Technical Service Bulletin

Subject: FRONT AND REAR BRAKE NOISE	Bulletin No.: 04-001/23
	Last Issued : 02/13/2023

2013-2023 CX-5

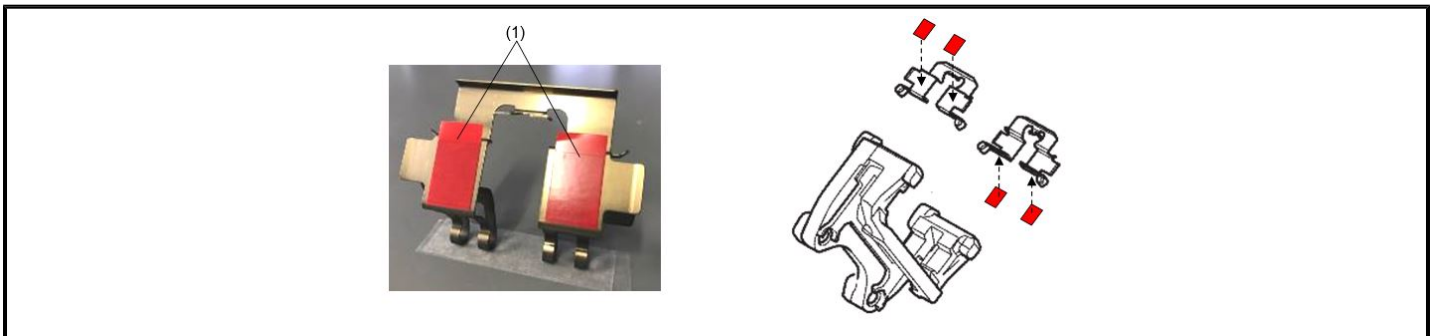
- Verify if the tape is installed to both guide plates (some kits do not have the tape installed and is packaged separately).
- If the tape is not applied to the guide plates, peel off the red release film (1) and the dual adhesive tape (2) from the release paper (3) and apply the dual adhesive tape to the contact surfaces of the guide plates as shown below.
